Product Change Notice

- Products : LM301B (SPMWHD32AMD*****)
LM301H (SPMWHD32AMH*****)
CCTs : 27/30/35/40/50/57/6500K
- Change : Lead frame Type A → Type B
- Remark : Scheduled to start manufacturing in Jan. 2024

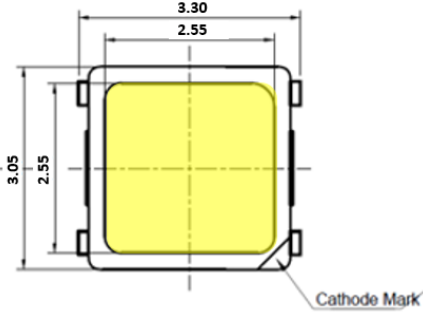
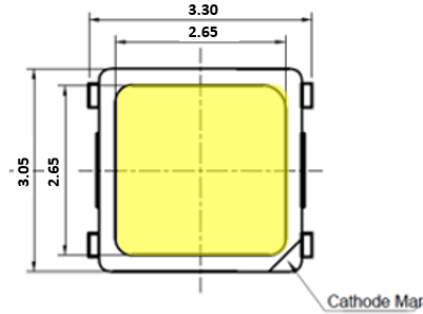
Lead Frame Change : Type A → Type B

Change	Remark
Material	L/F	Type A → Type B	PCT (Same with LM301B EVO)
Electrical Performance		Same as before	-
Mechanical		Same as before	-
Beam angle		Same as before	-
Radiating Characteristics		Same as before	-
PKG Image		<div>As is</div>  <div>→</div> <div>To be</div> 	-

3-1. Sweep Performance

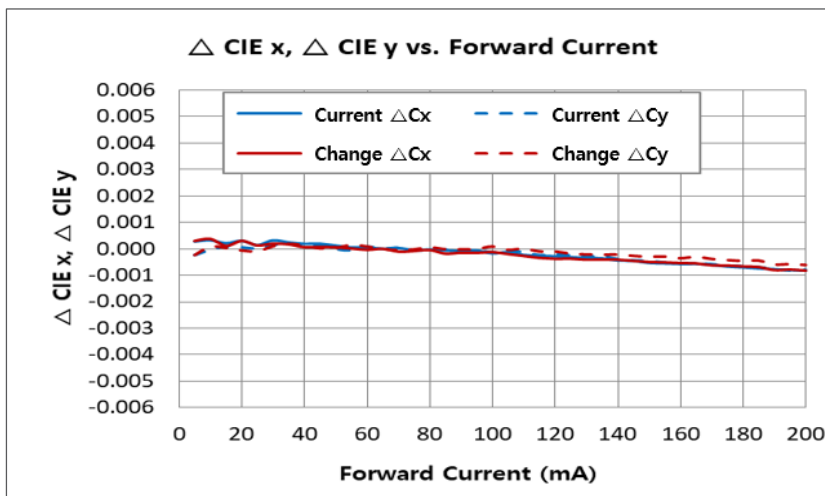
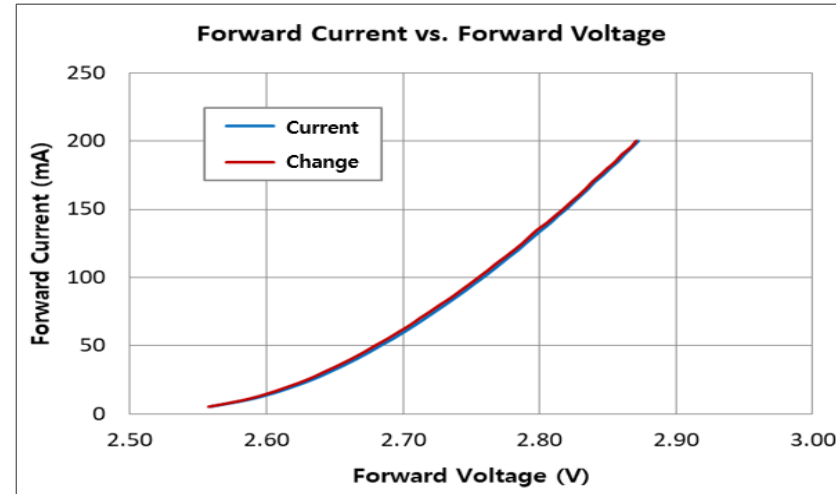
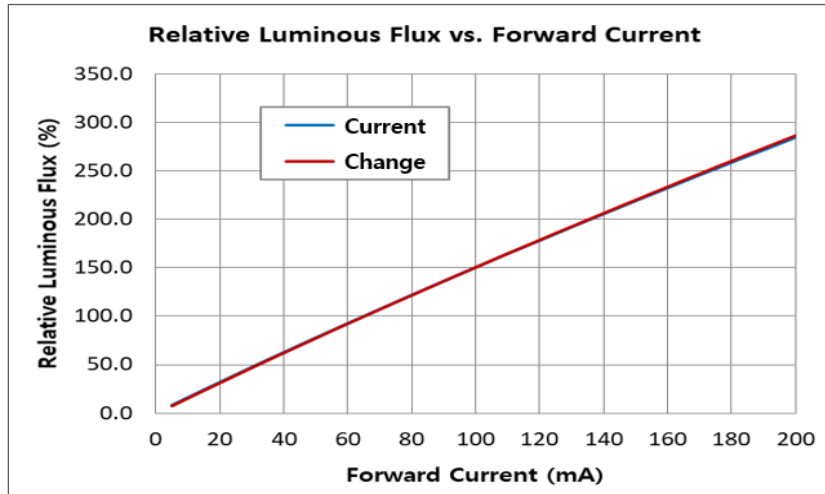
No change Characteristics with Current sweep

3-2. Temperature Performance

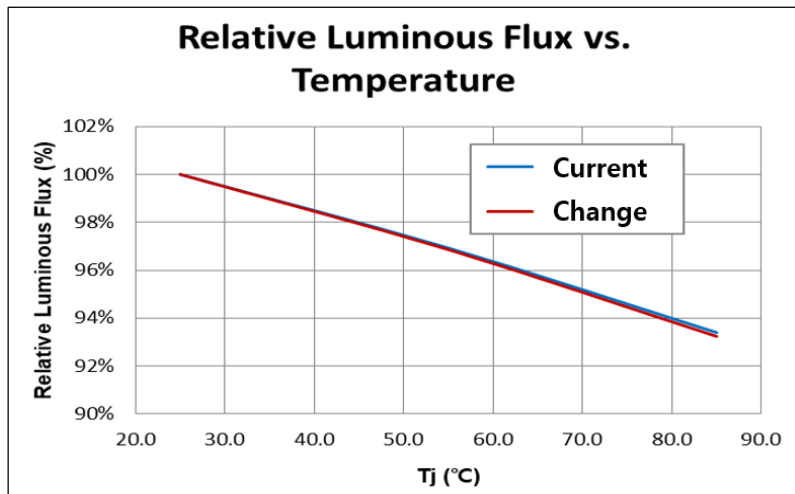
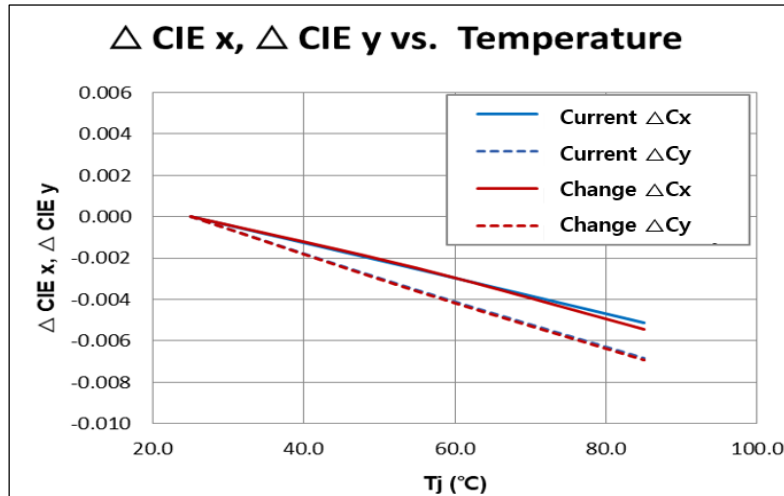
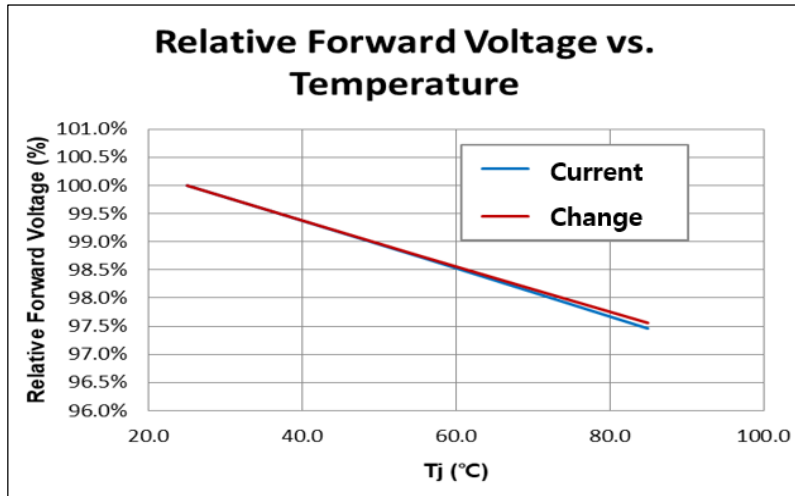
No change Characteristics with Temperature

Radiation diagram

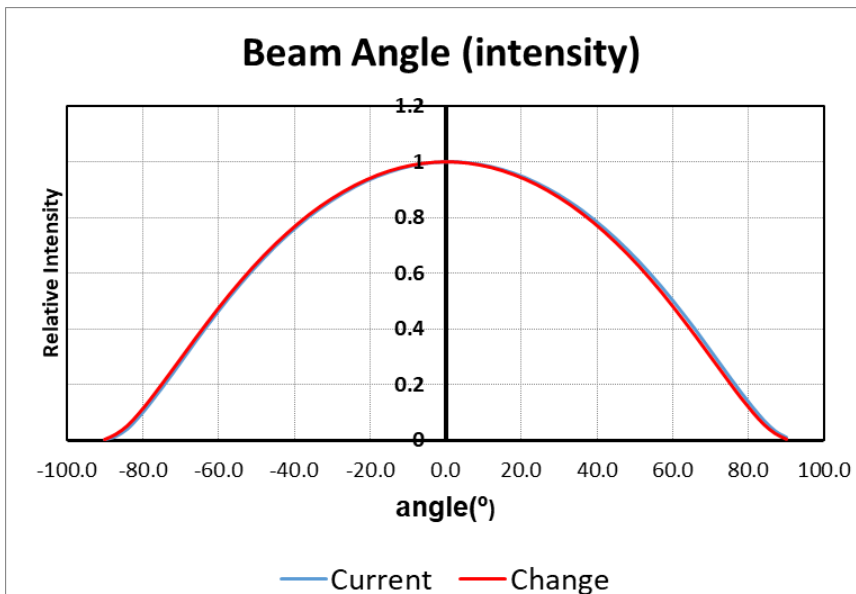
No change Optical Characteristics

4. Reliability

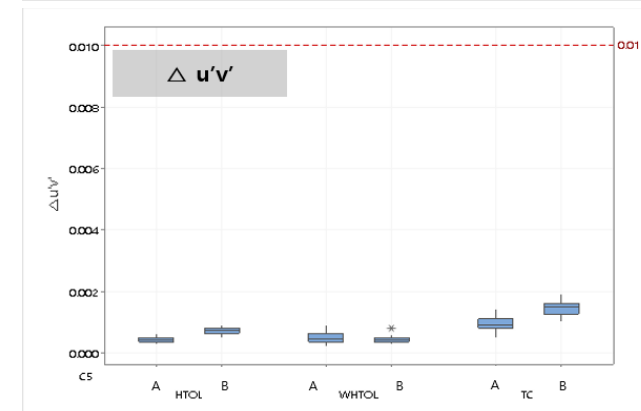
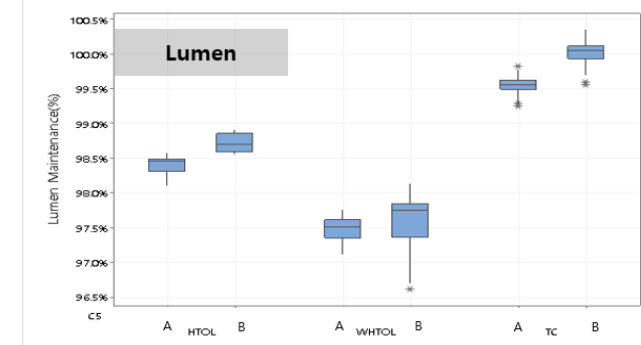
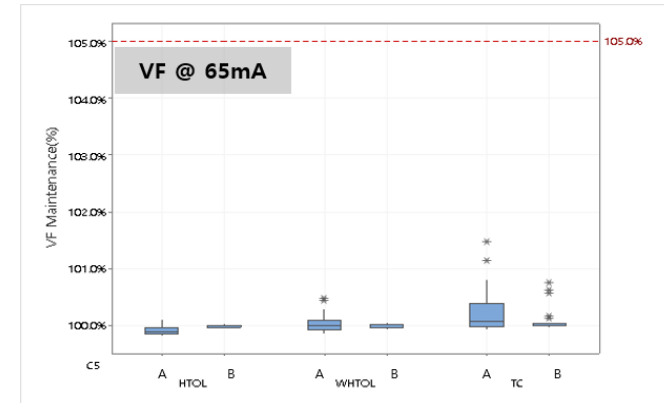
PASS criteria in the specification
